KAWARTHA PINE RIDGE DISTRICT SCHOOL BOARD
PUR24-100-ITT
Murray Centennial Public School Addition

ADDENDUM NO. 3

Add (1): Architectural Addendum No. 2, Prepared by Moffet and Duncan Architects Inc. (34 Pages)

REFLECTED CEILING LEGEND

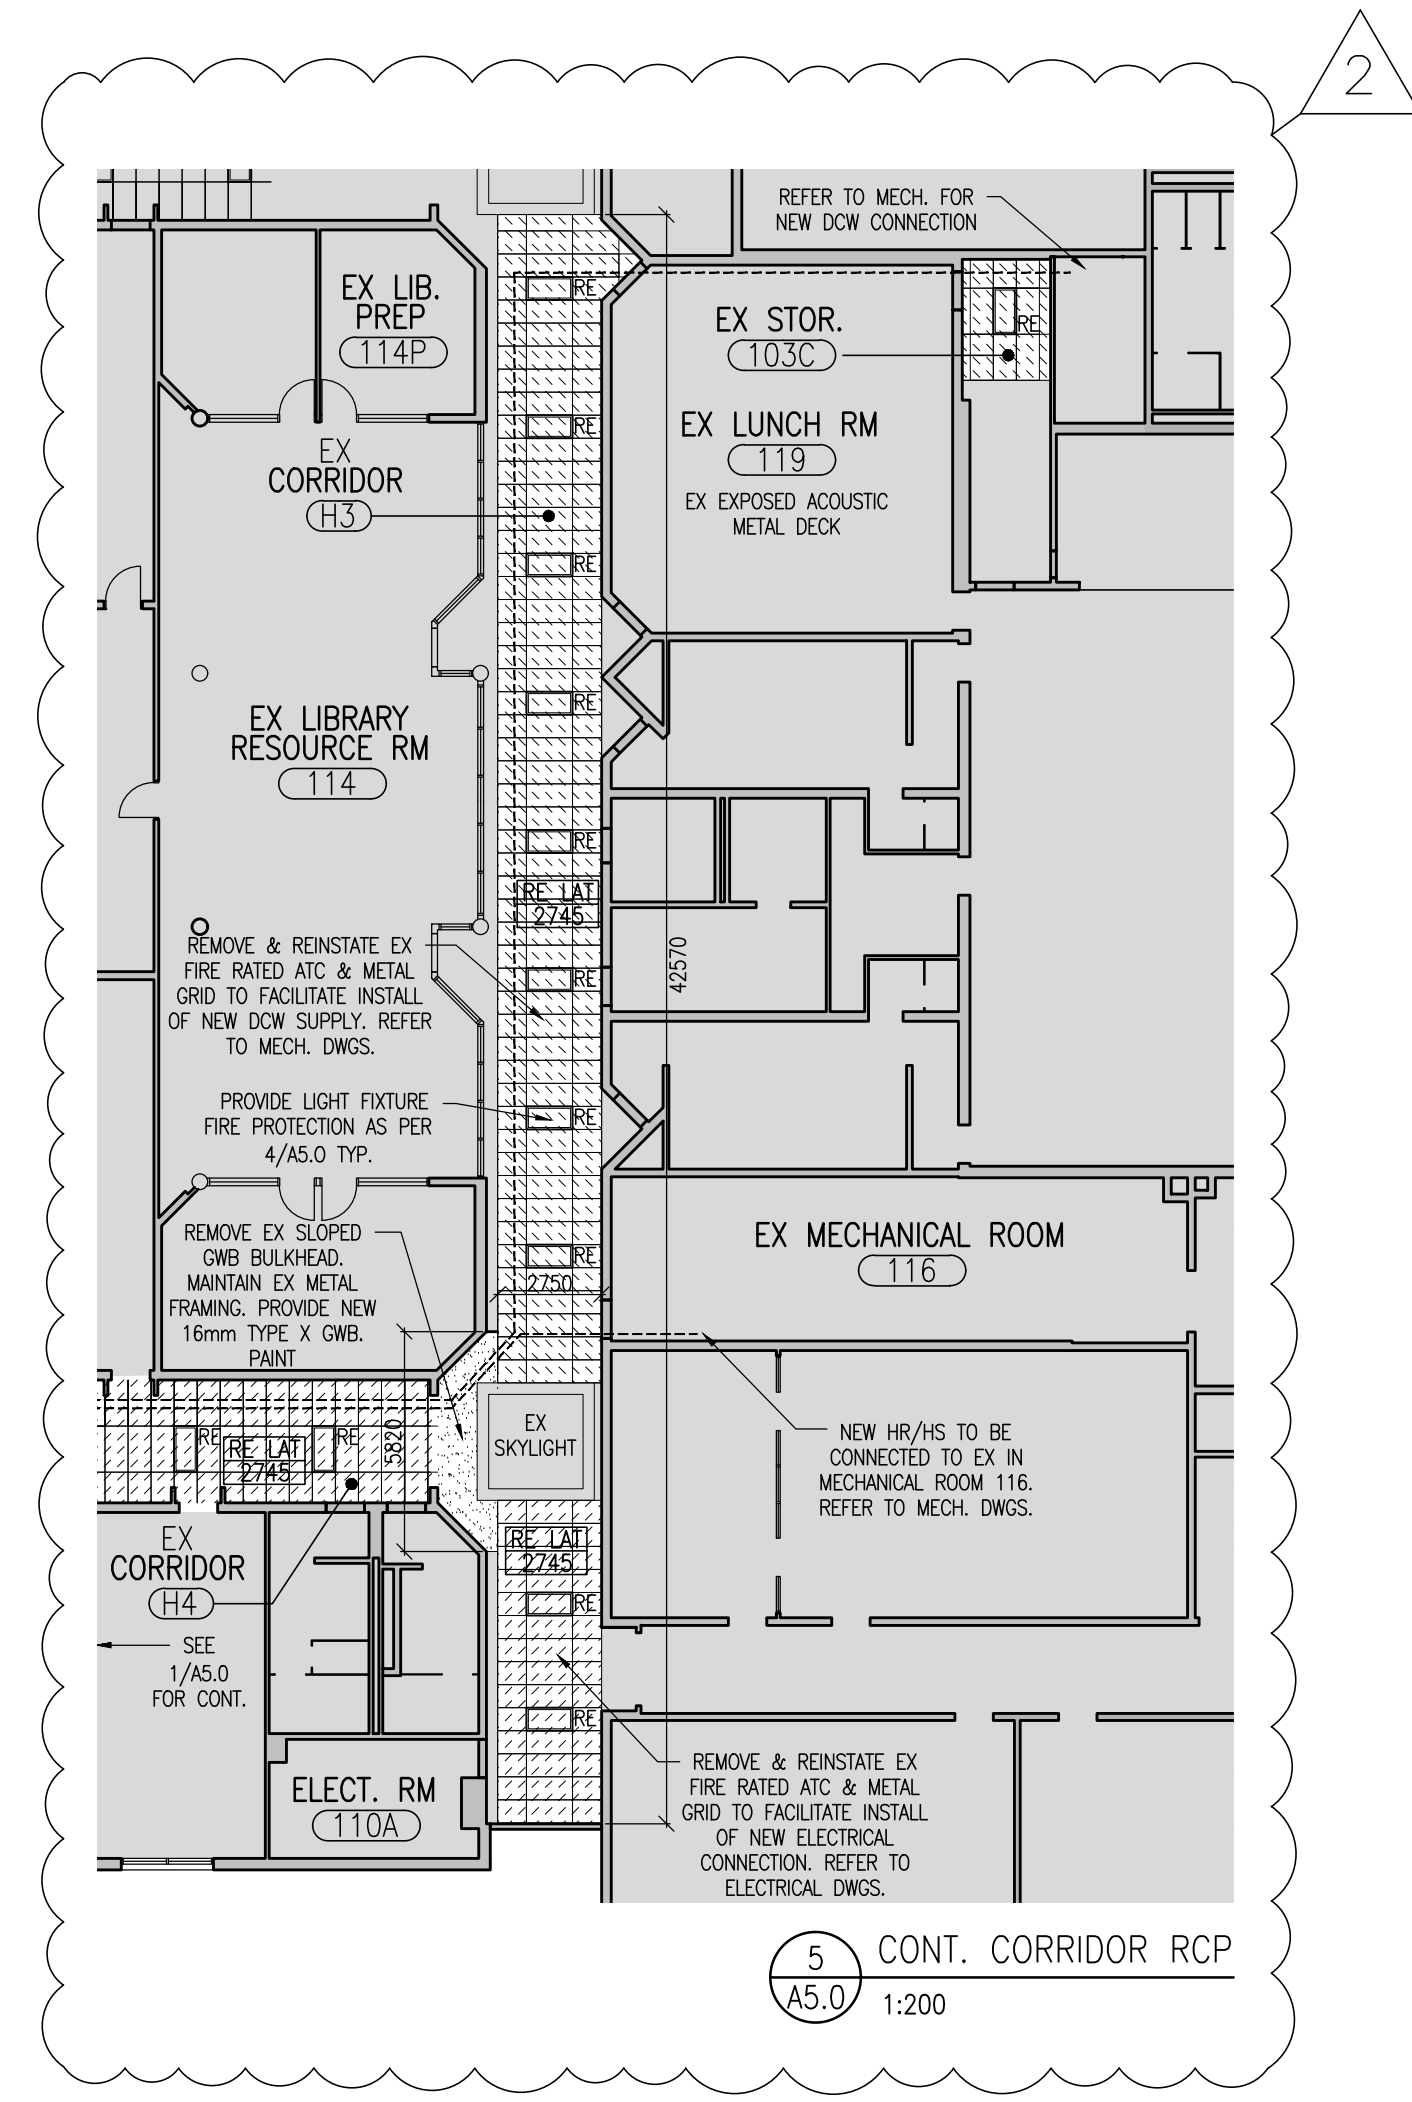
- .1 Replace Drawing A5.0 with enclosed Drawing A5.0 Addendum 2. Refer to Dwg 5/A5.0 for additional ceiling removal and reinstallation in existing Corridor H3 and H4. Refer to Drawing 1/A5.0 for revised ceiling removal and reinstallation in existing classrooms. Refer to revised notes in "Reflecting Ceiling Legend".

PHASE 1 - PARTIAL DEMO PLAN - TEMPORARY EXITS
1:100

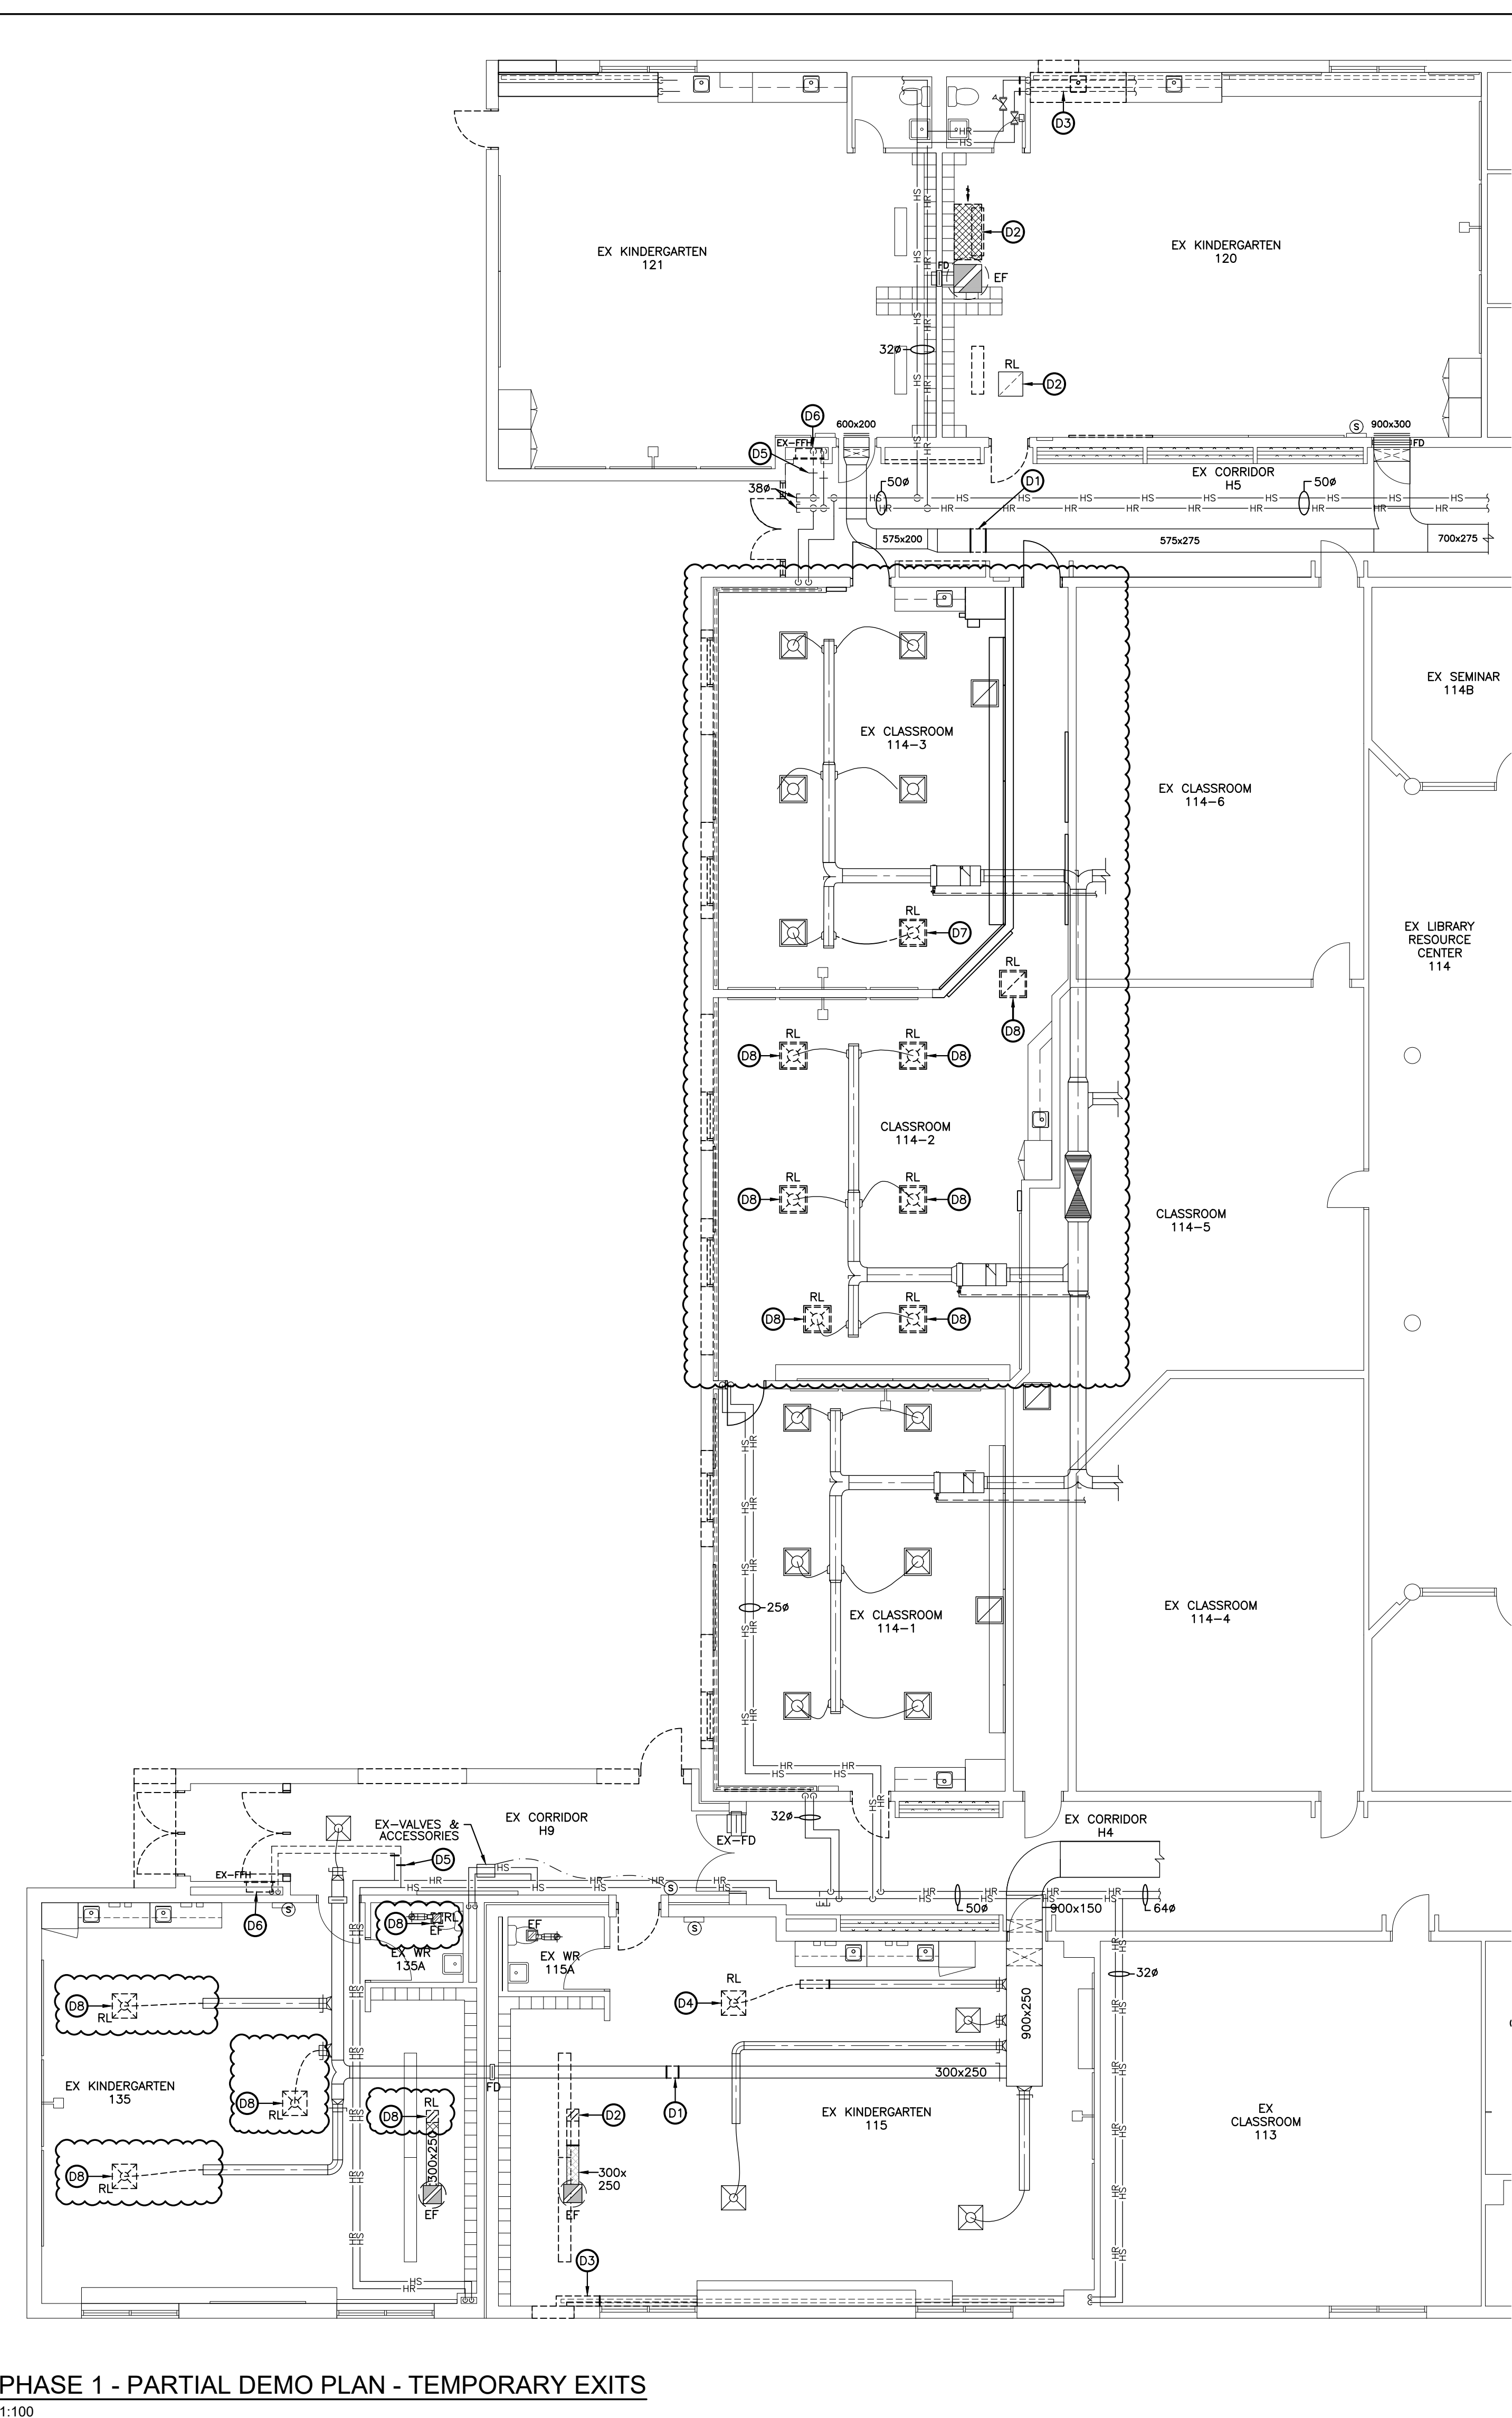
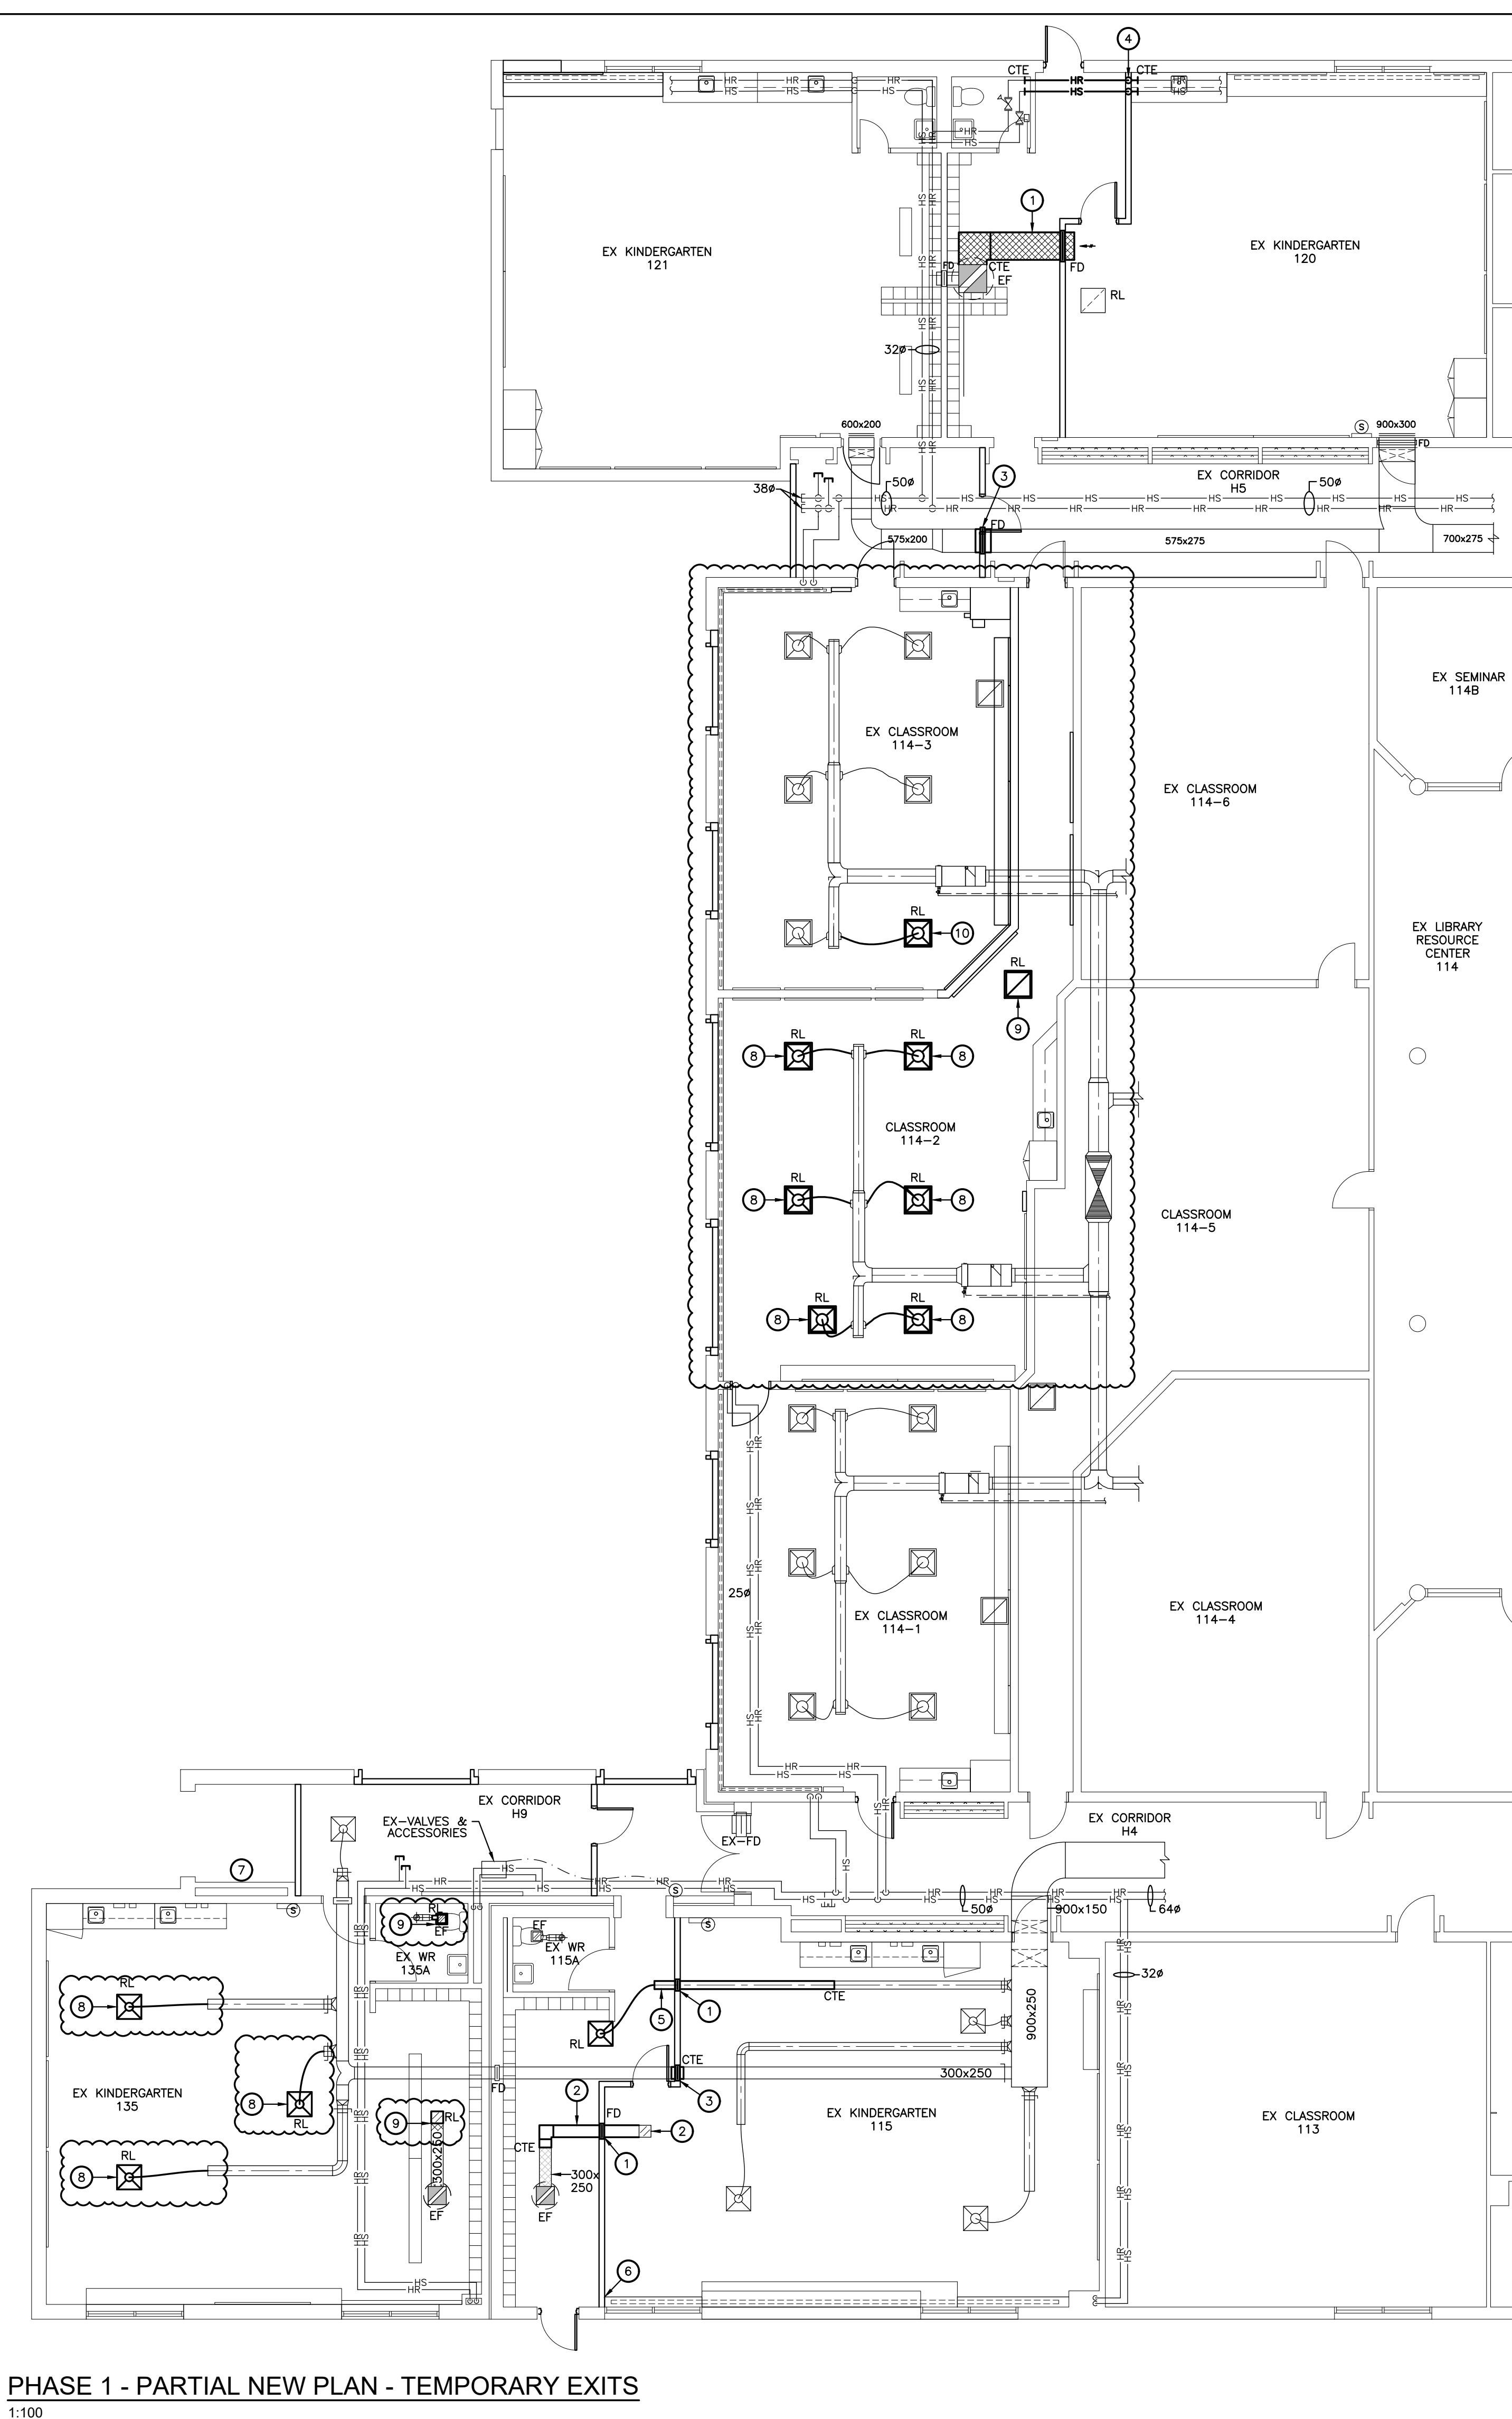
- .1 Refer to revised drawing. Work for certain areas shall be undertaken under Phase 3.
- .2 Disconnect and remove all diffusers and grilles in Classroom 114-2 and 135 as part of Phase 3 demolition plan and retain for reinstallation.

- .3 Re-install existing supply diffusers and connect to the existing supply duct. Re-install existing return grilles and connect to existing return ducts in Classroom 114-2 and 135. Provide fire damper at rated walls as part of Phase 3 construction plan to facilitate temporary exiting strategy.

- .4 Disconnect and remove the diffusers in Classroom 114-3 as shown on revised drawing and cut back duct in Classroom 114-3 as indicated in revised drawing.

- .5 Re-install existing supply diffuser and connect to the existing supply duct in Classroom 114-3.
- .6 Supply duct serving Classroom 114-3 to be complete with fire damper at rated walls as part of Phase 3 construction plan to facilitate temporary exiting strategy.

- .7 Existing exhaust fan grille in Washroom 135A to be removed as part of Phase 3 demolition plan and re-install after re-installation of RCP as part of Phase 3 construction plan.
